From: Scala, Mary Joy
Sent: Wednesday, January 18, 2017 2:47 PM
To: Steigman, Trey; 'Stephen von Storch'; Steve Houchens
Cc: Charlie Armstrong (CharlesA@southern-development.com); Alfele, Matthew
Subject: BAR Action - William Taylor Plaza 2 - Jan 17, 2017

BAR 16-08-05

NW Corner of Ridge Street and Cherry Avenue (William Taylor Plaza Phase 2)
Tax Parcel 290147000, 290146000, 290145000
Cherry Ave Investments LLC, Owner/ Management Services Corp., Applicant
Landscape Plan and Final Details

**CITY OF CHARLOTTESVILLE
BOARD OF ARCHITECTURAL REVIEW
STAFF REPORT
January 17, 2016**

LANDSCAPE PLAN

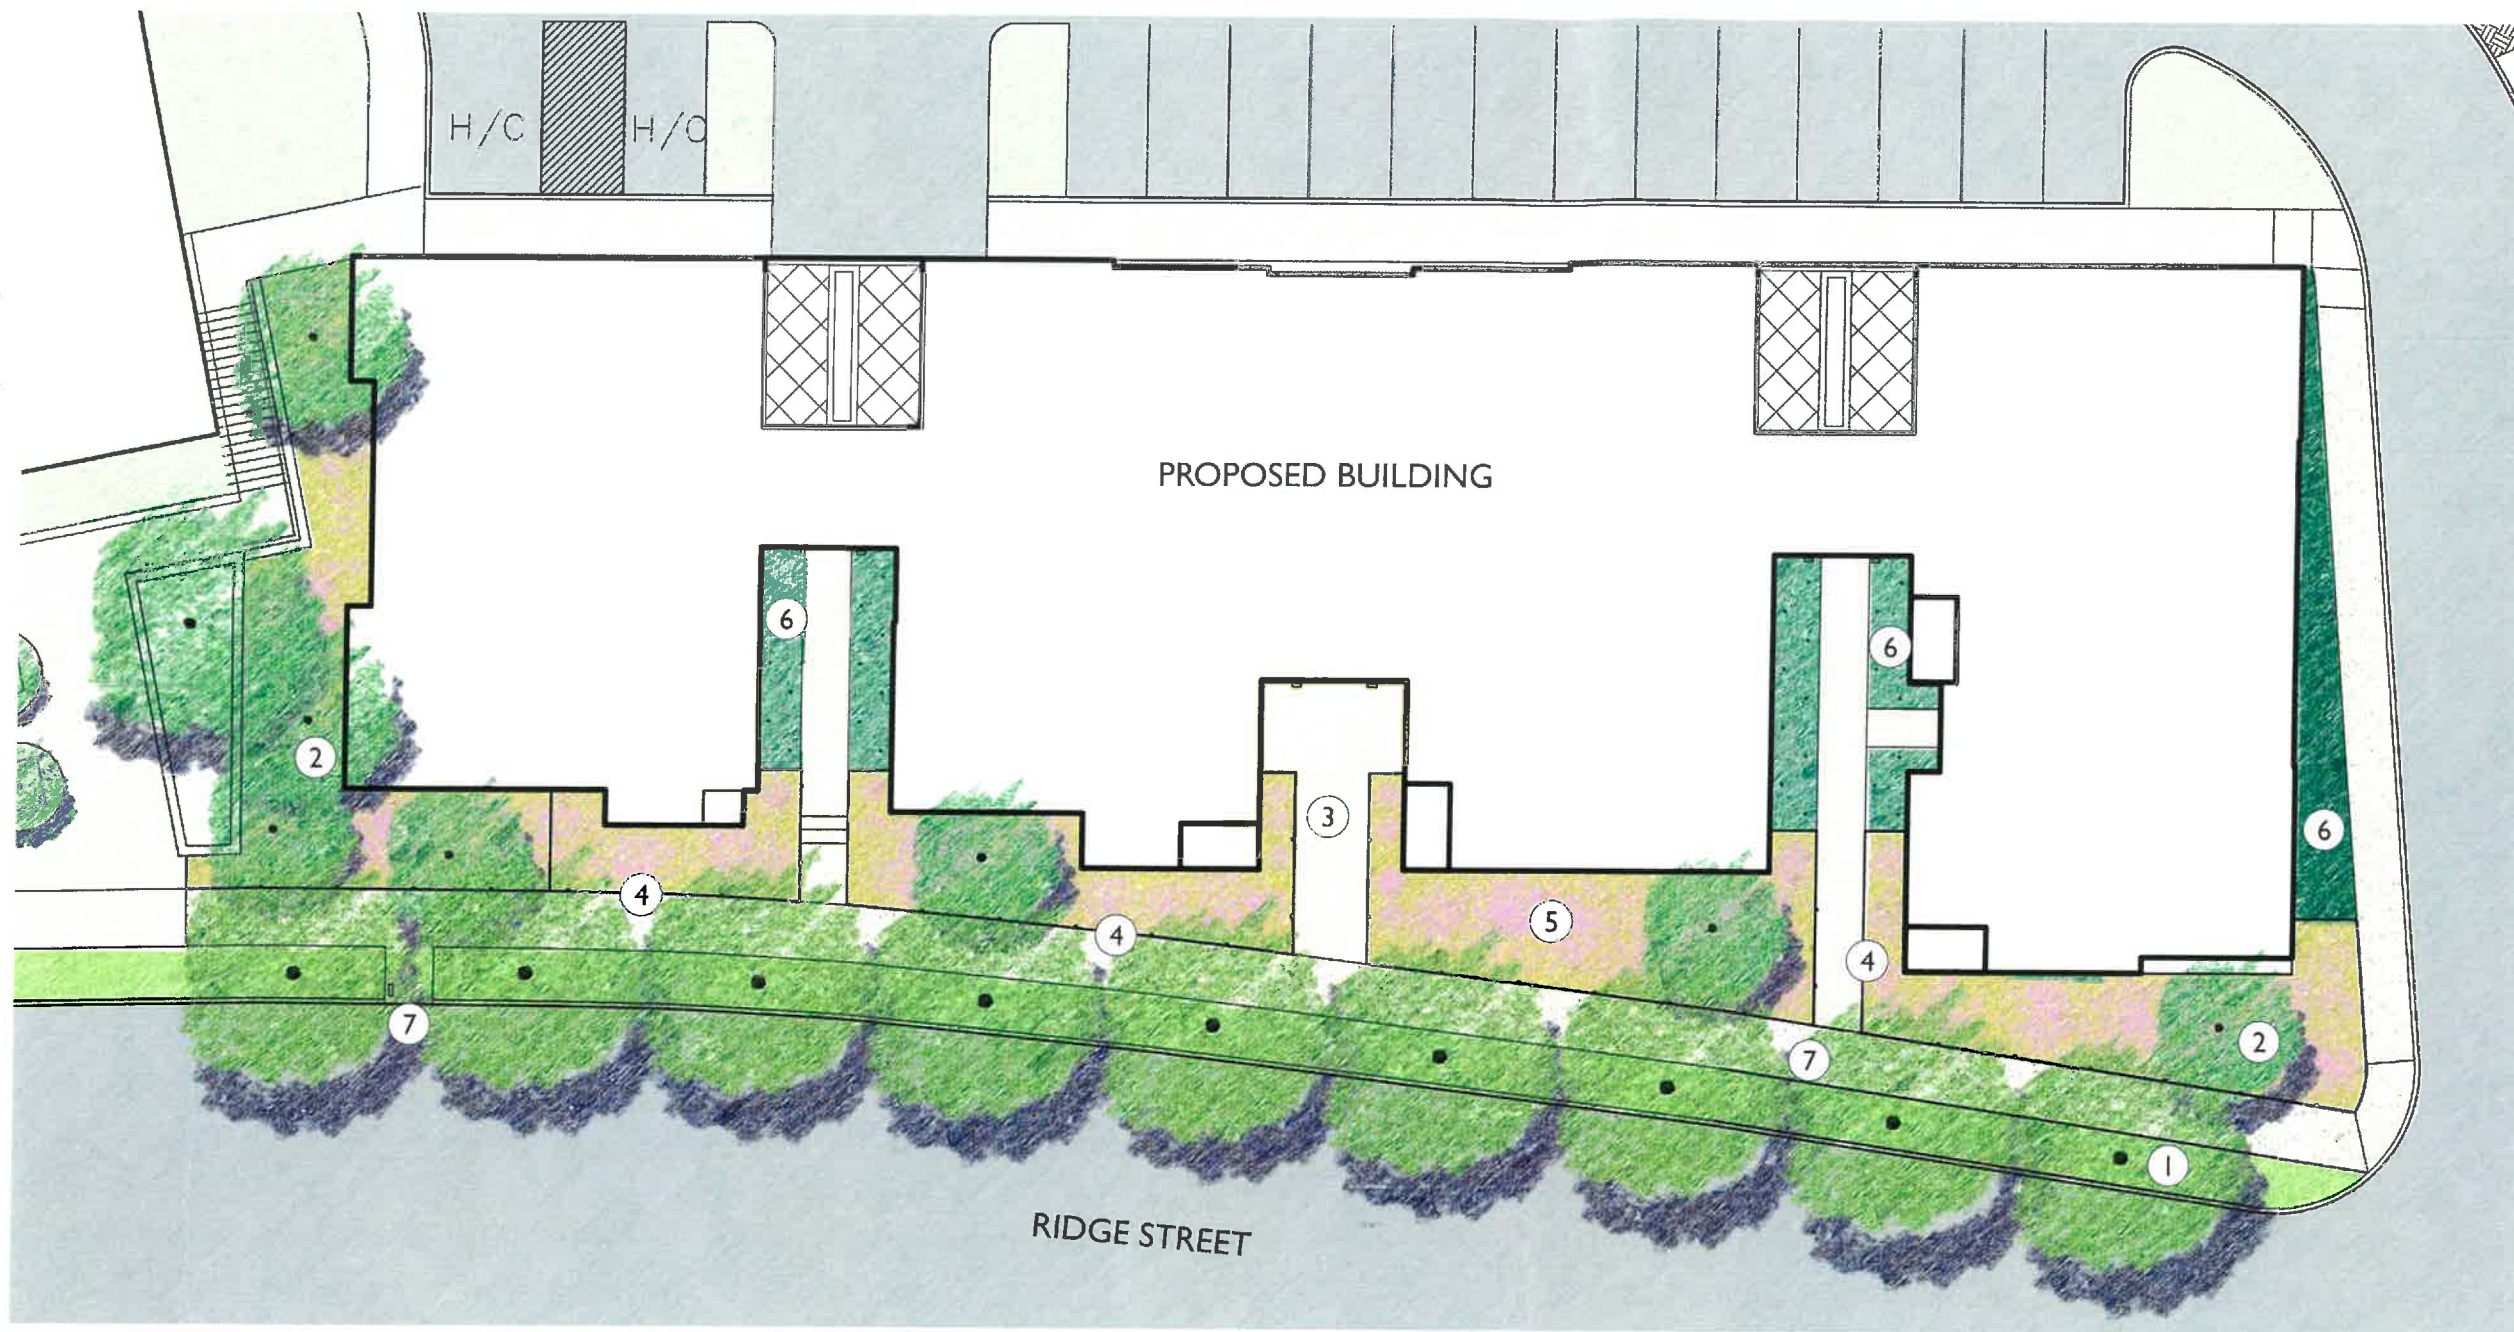
Schwarz moved to find that the landscape plan for the proposed new residential building satisfies the BAR's criteria and guidelines and is compatible with this property and other properties in the Ridge Street ADC district, and that the BAR approves the landscape plan as submitted and asks that the applicant give consideration to the trees on the south end of the building, and approve administratively a final plan with every tree with its species, what lighting fixture will be used for the porch balconies, and more details on the Corten wall (approve with the Corten wall turning the corner) and the BAR wants to see a Phase I site plan to match this plan in the area of the plaza. Clayborne seconded, and the motion passed 5-0.

Staff has asked the applicant to coordinate the landscape plan with the hotel site plan on the east end. The hotel site plan shows a brick site wall at the plaza, and on the Phase 2 site it shows two red maple trees and a storm water device in the rear corner that do not match up with this proposed landscape plan.

LANDSCAPE PLAN

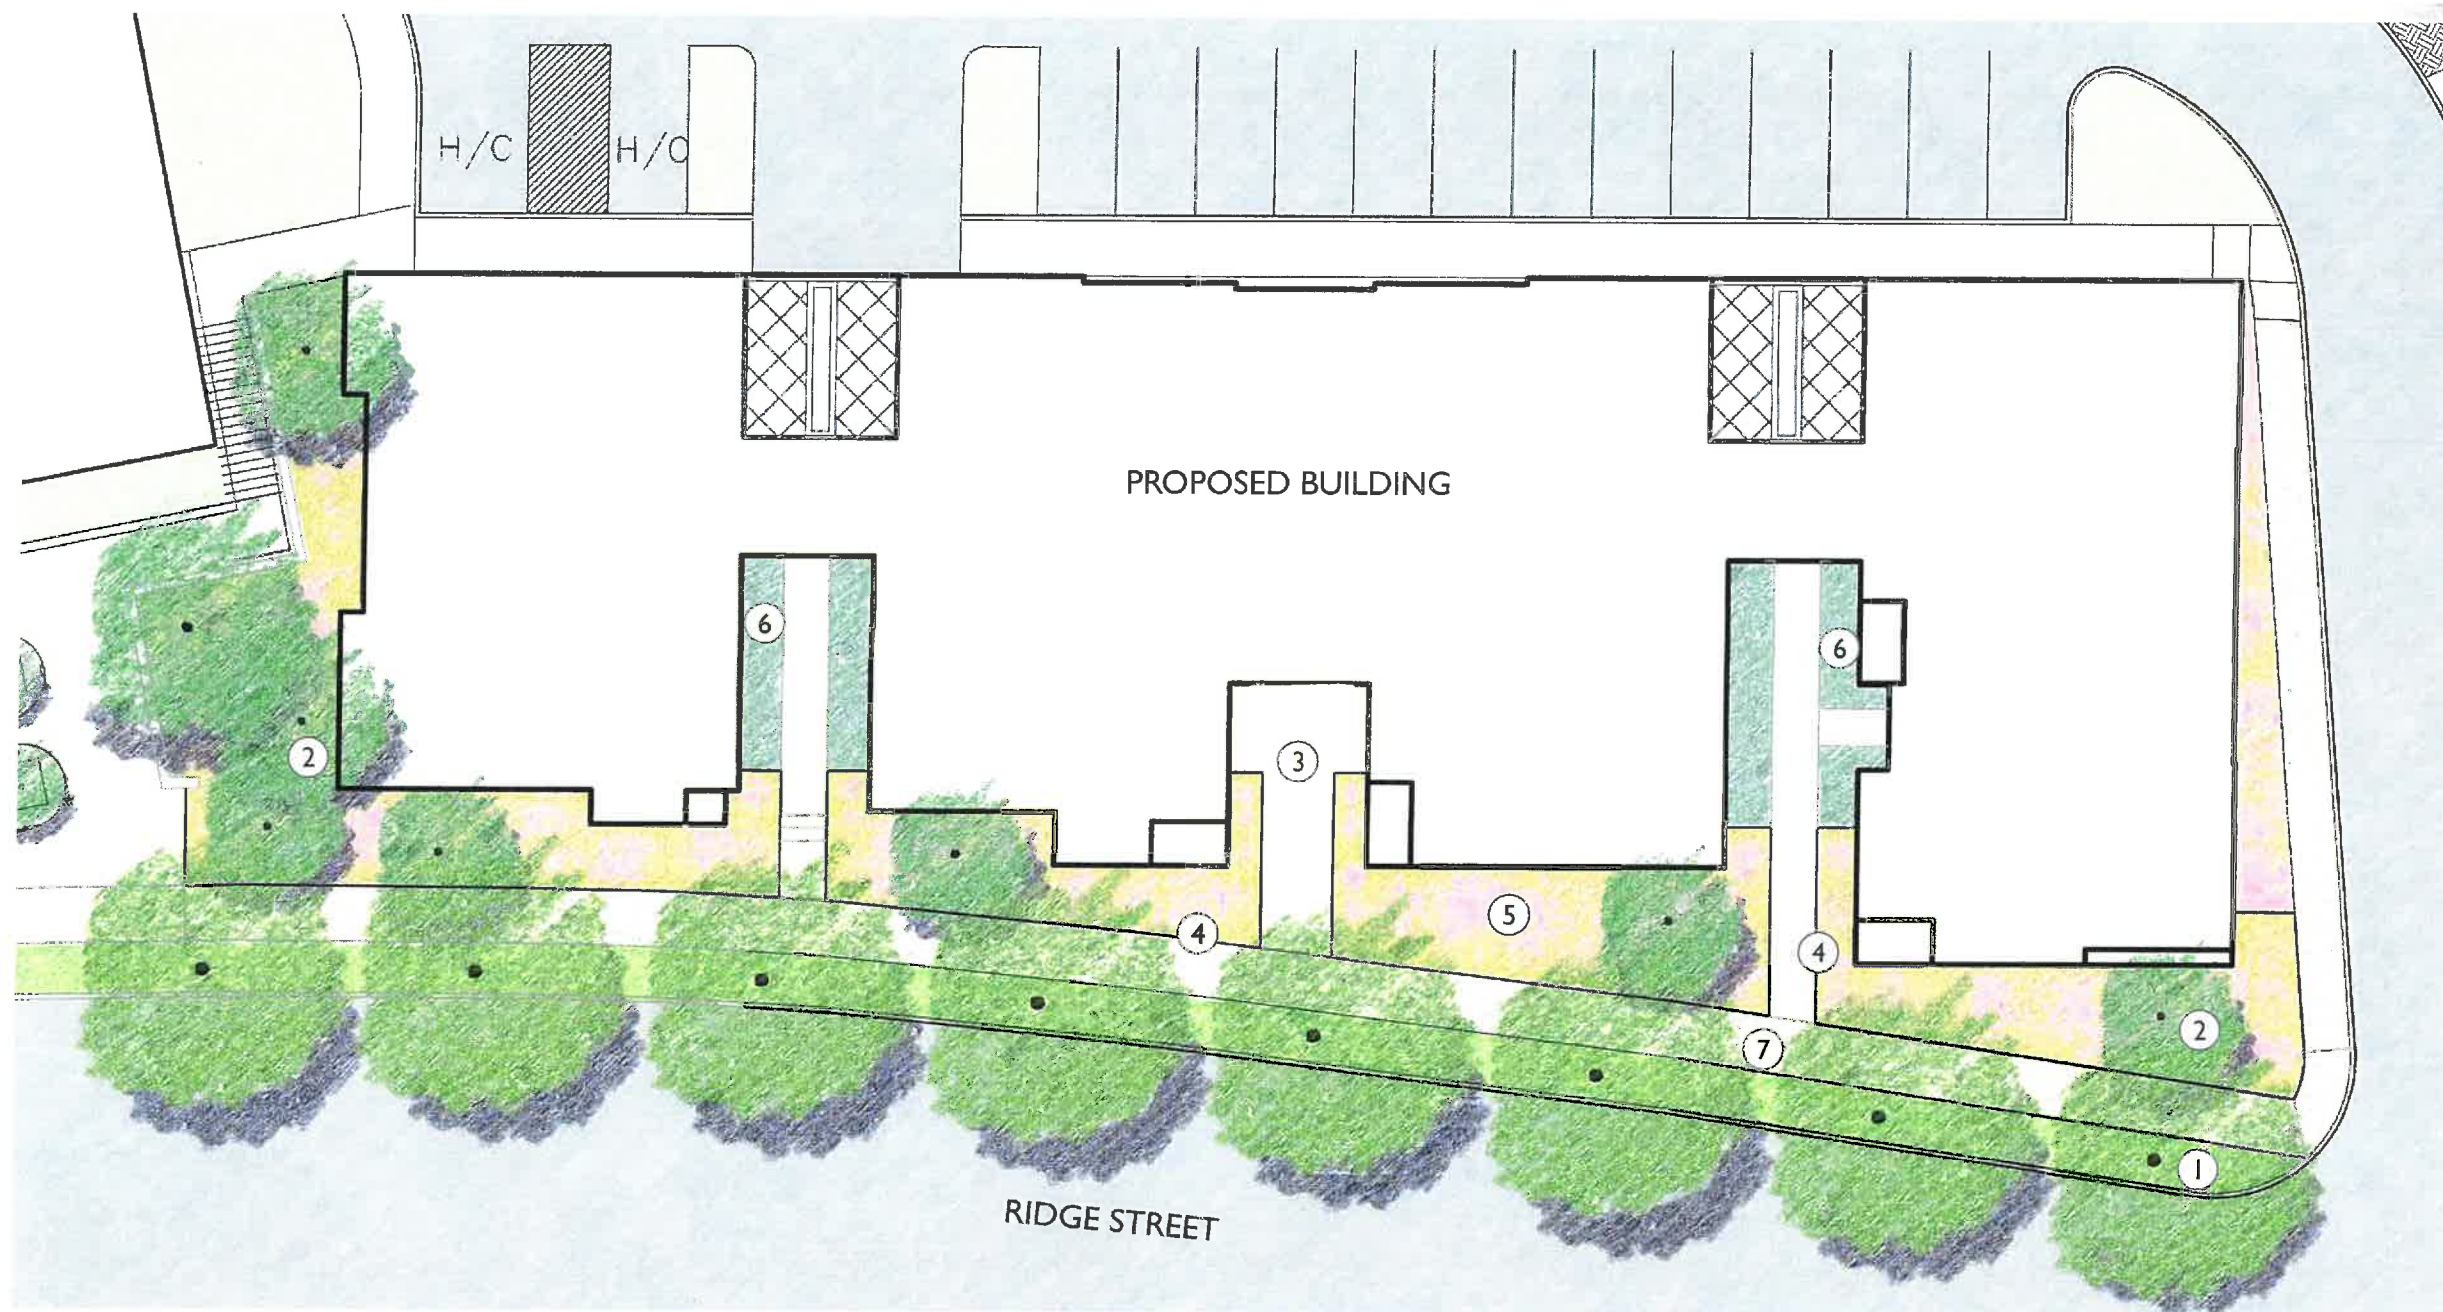
The landscape plan shows 8 London Plane trees along Ridge Street (with the bus pull-off removed); 5 Serviceberry and 3 Sweetbay Magnolias planted on the site, Corten steel planter walls; other plantings; and concrete walkways.
